CITY COUNCIL AGENDA

Monday, January 5, 2026

STAFF ORIGINATOR: Katie Larsen, City Planner

Re: Lyngblomsten Nursing Home – Skilled Nursing Addition
Revised Preliminary PUD Plan Review
027097-000

GRADING PLAN

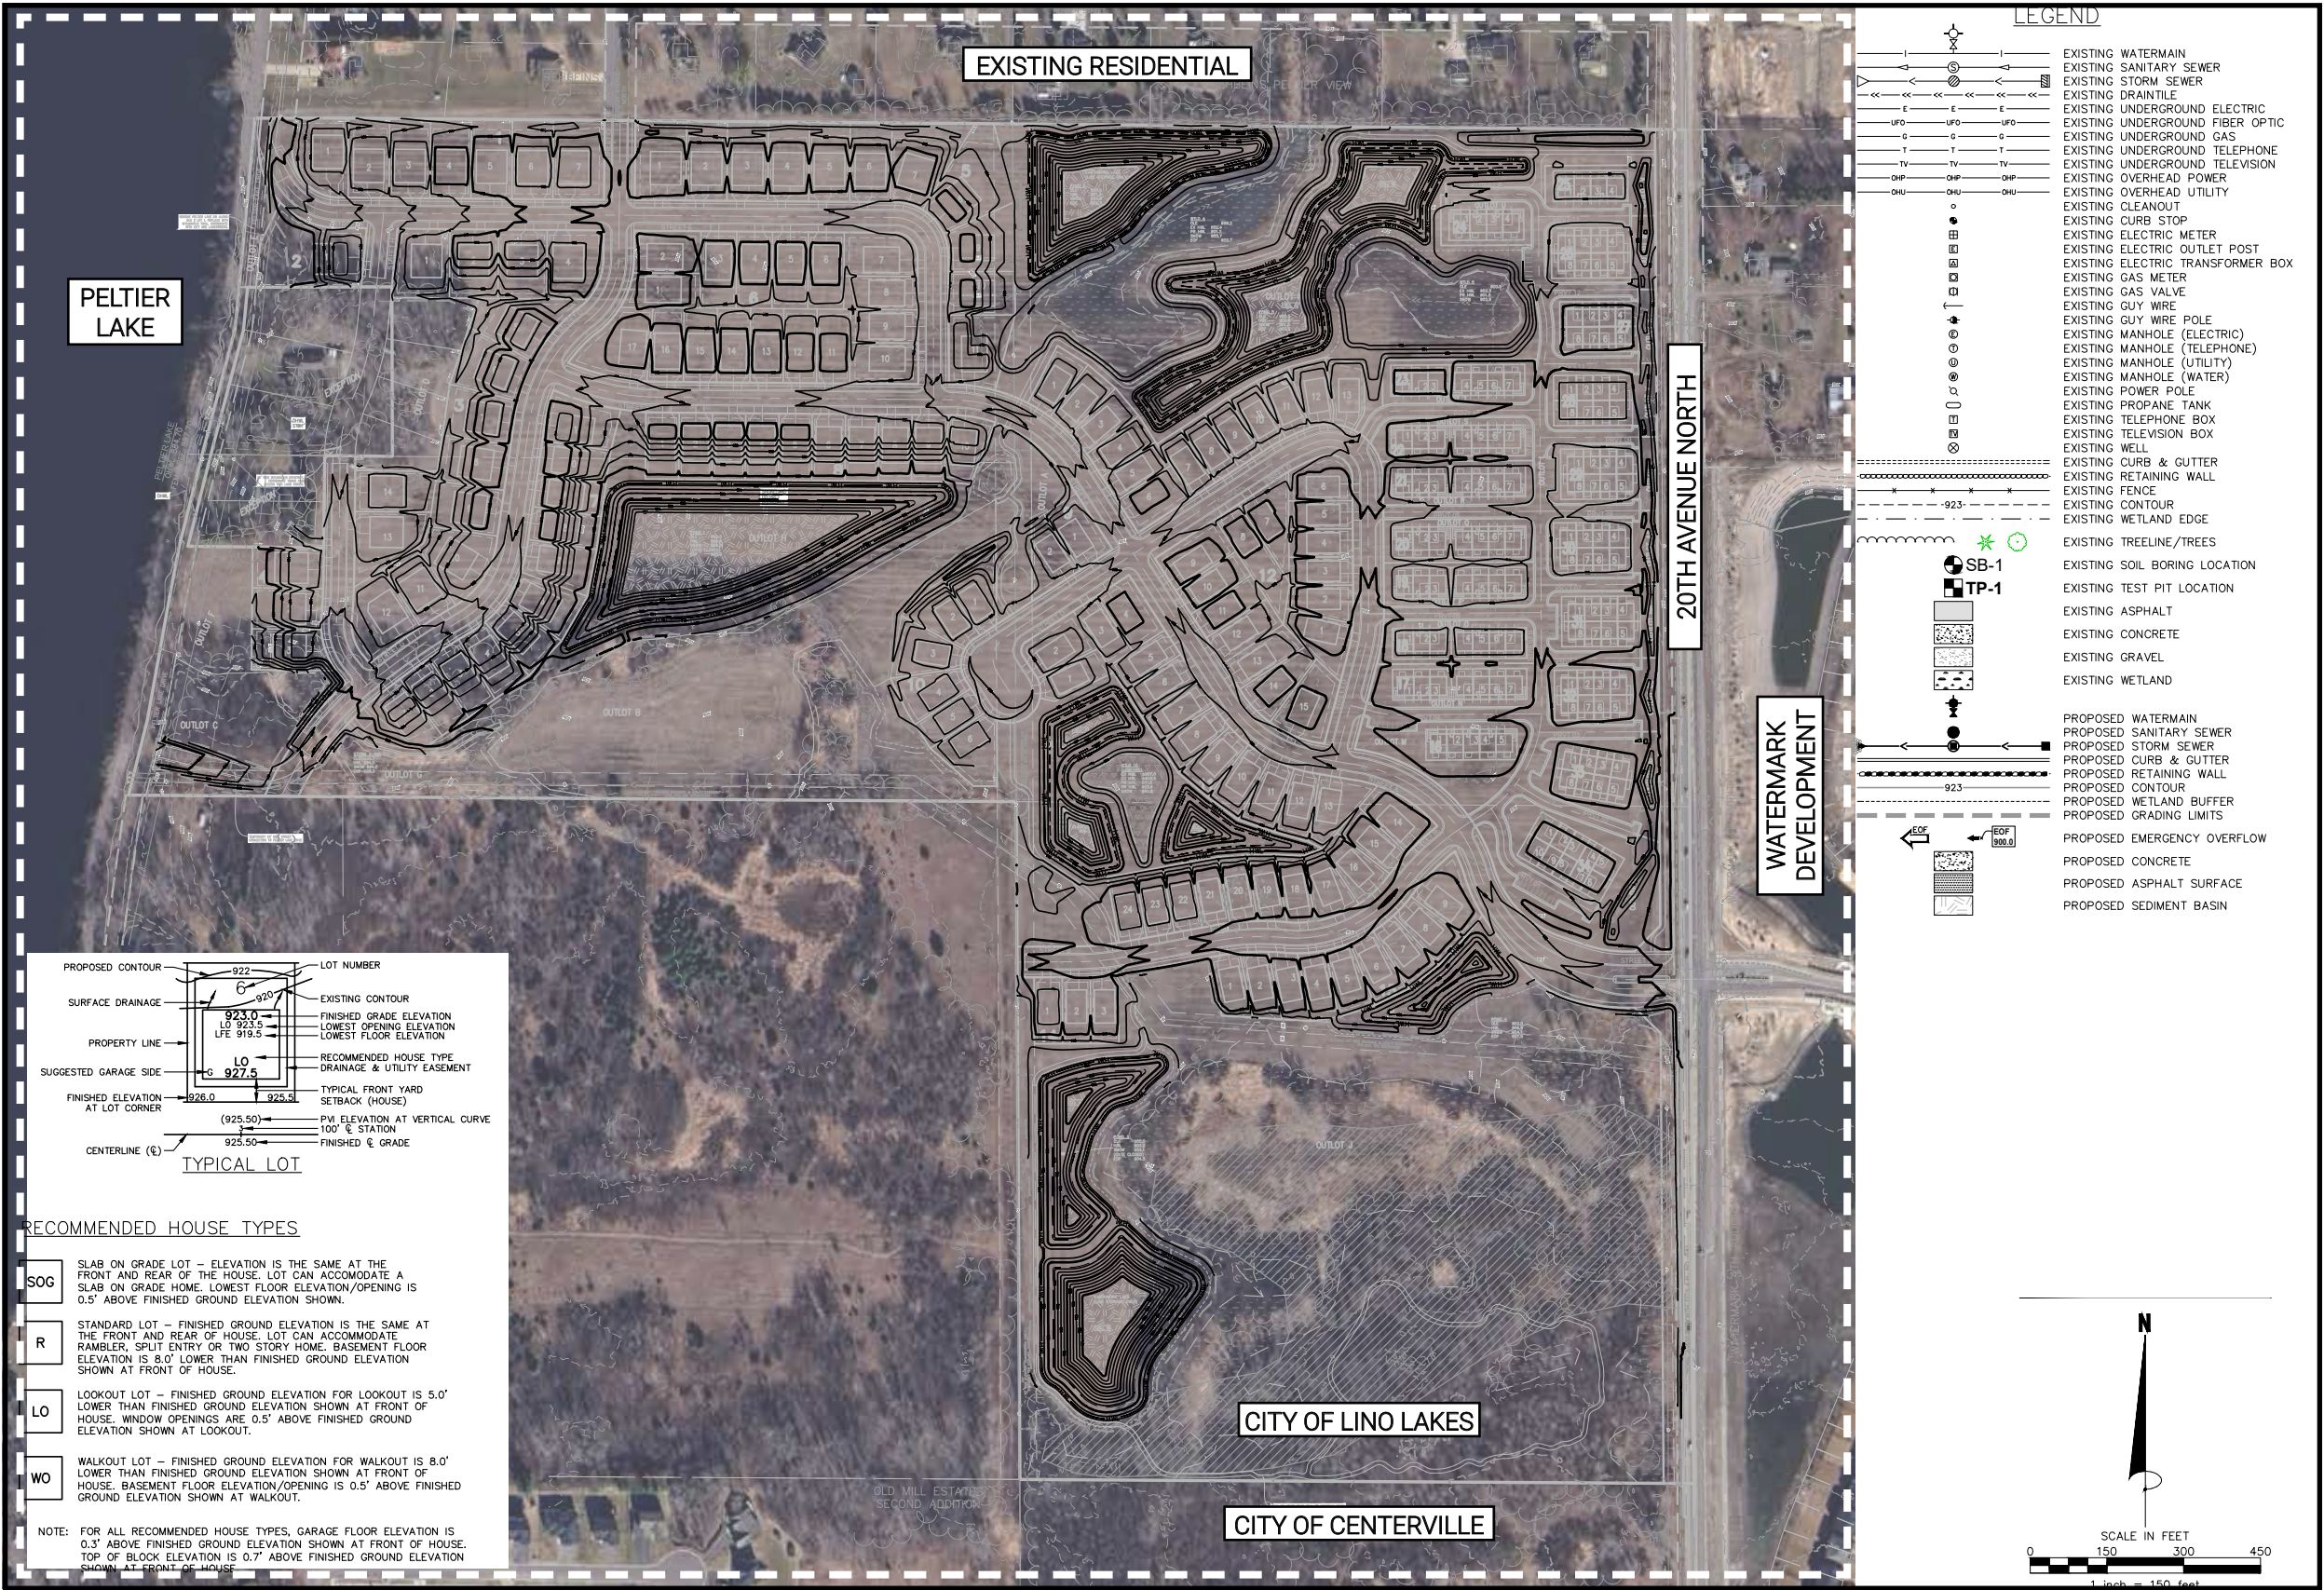
13. Sheet C4.4, Grading & Drainage Plan:
 - a. A temporary cul de sac shall be installed at the north end of Street H.
14. Sheet C7.1, Phasing Plan – U&S:

CAD FILE
24205-L
PROJECT NO.
24205
L1.3

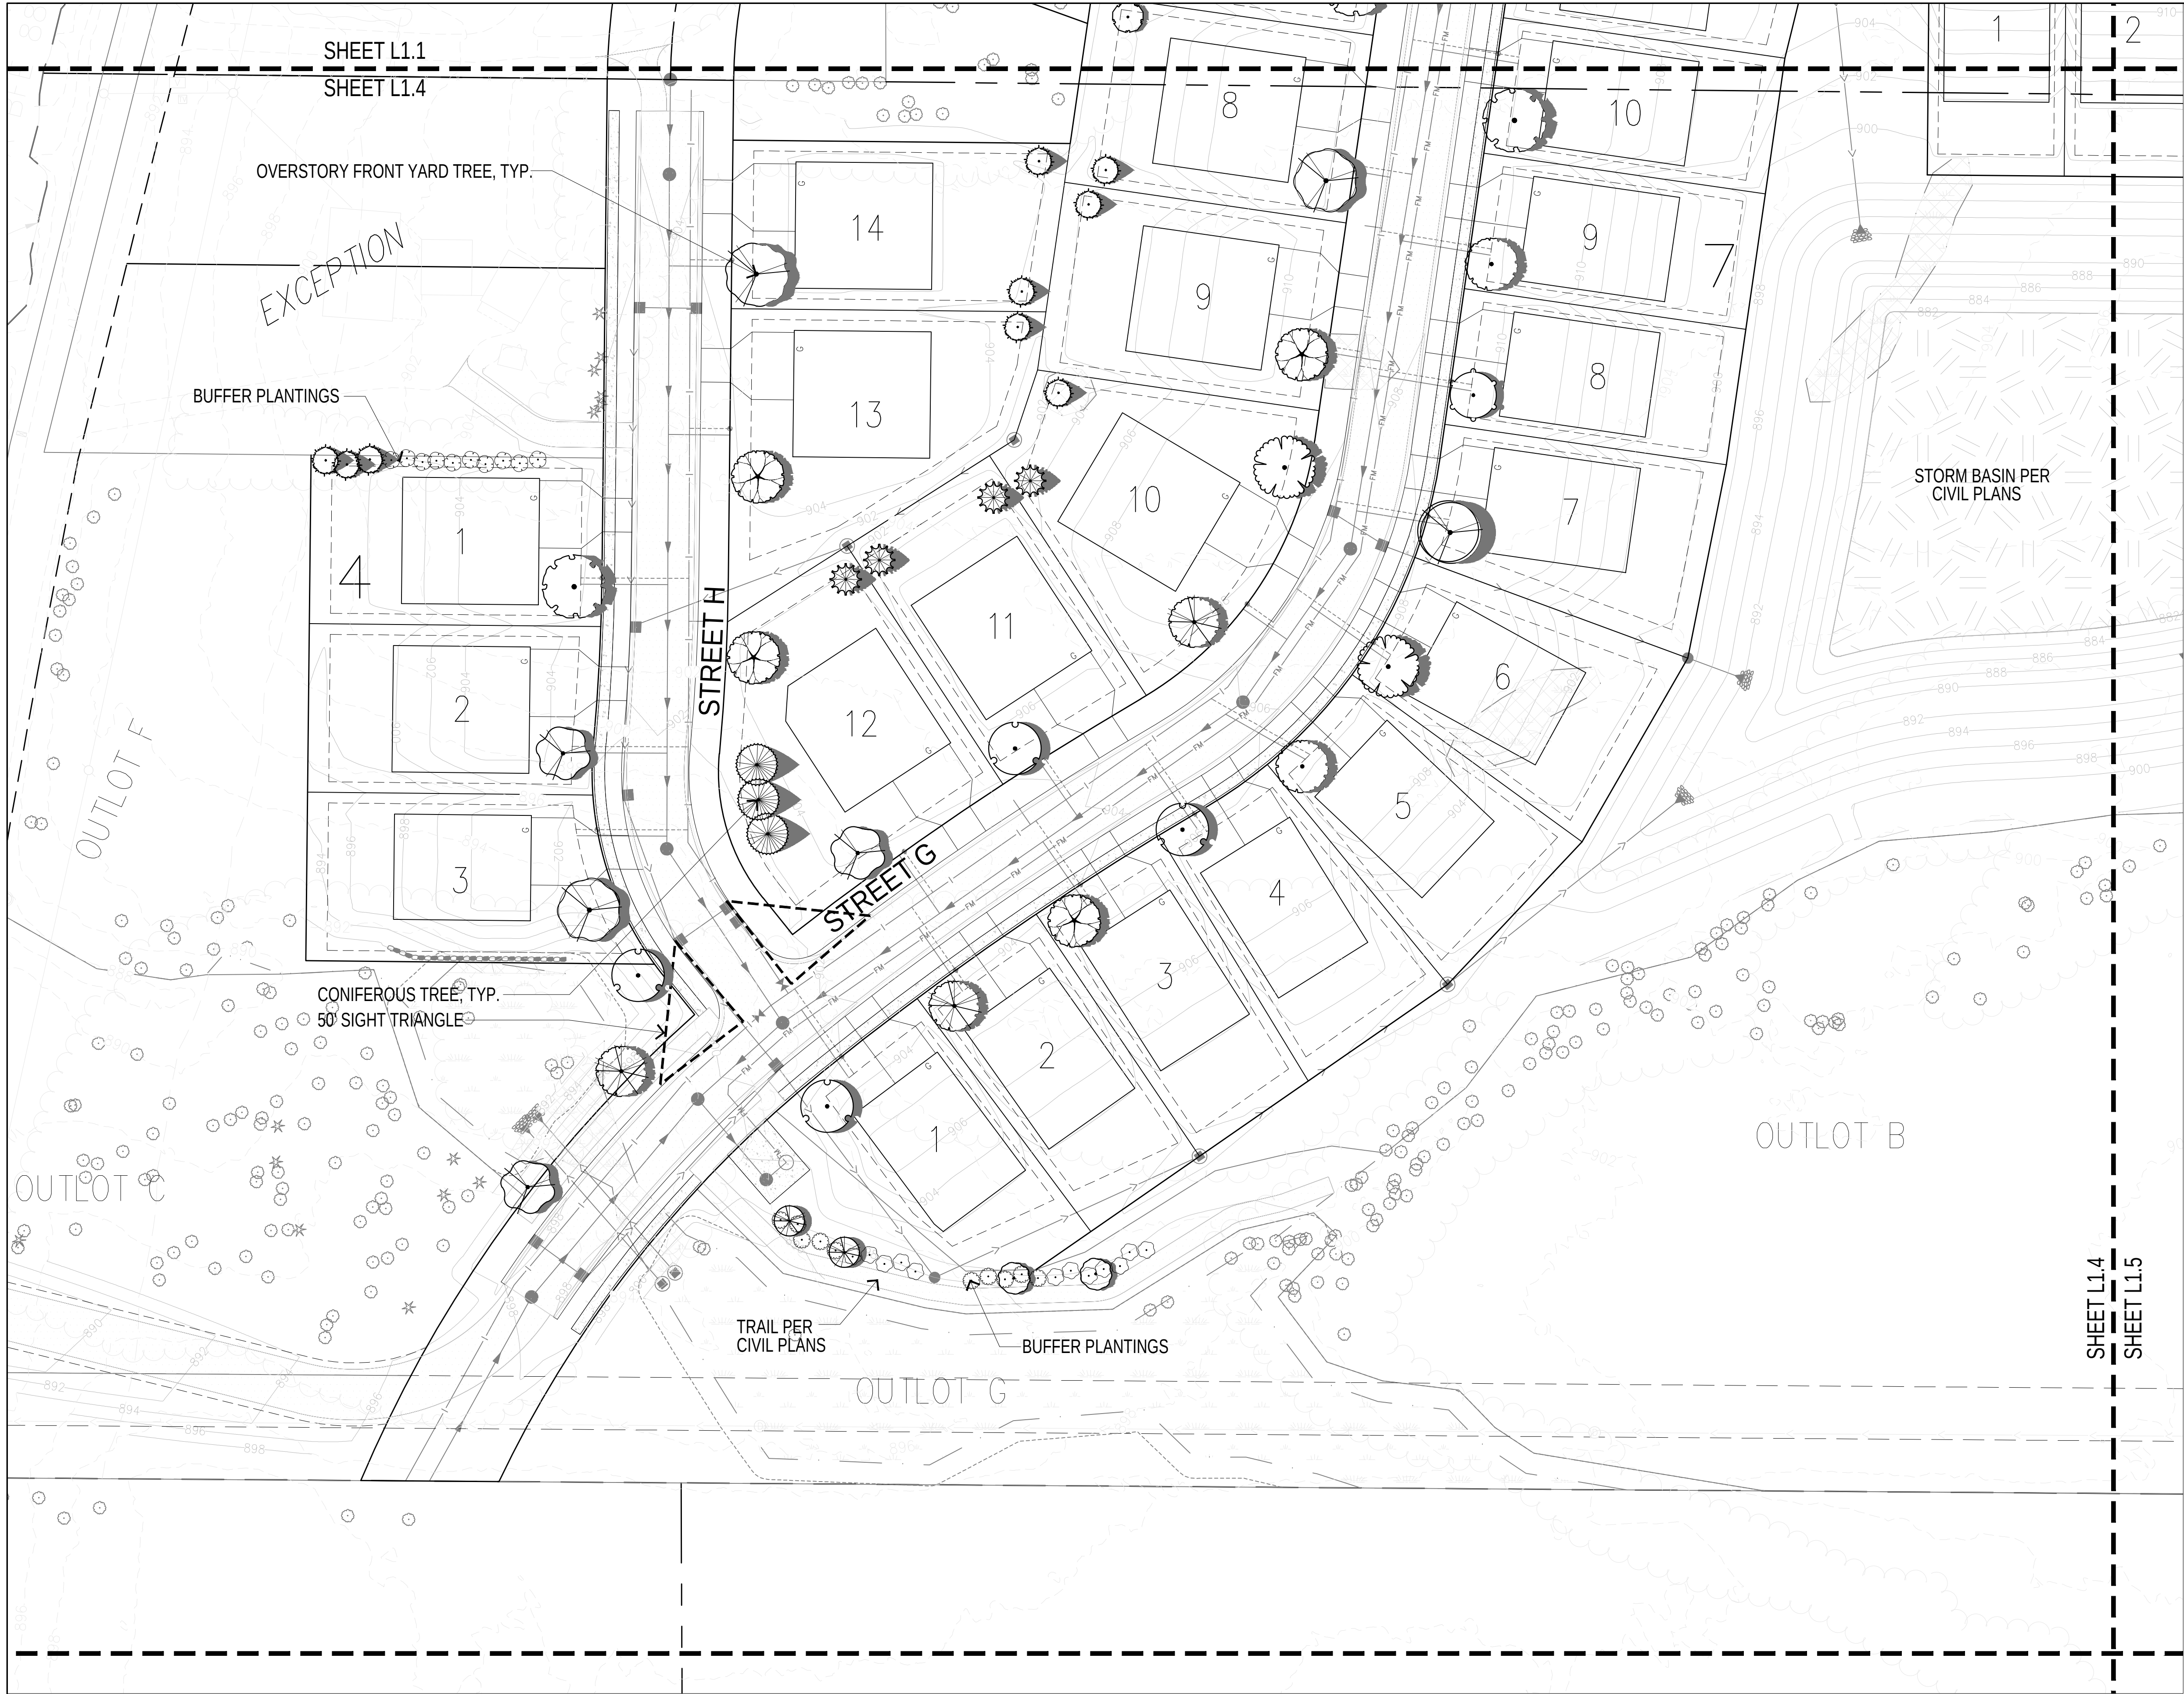
- c. Sheet L1.13 shall show the Existing Trees to be Removed.
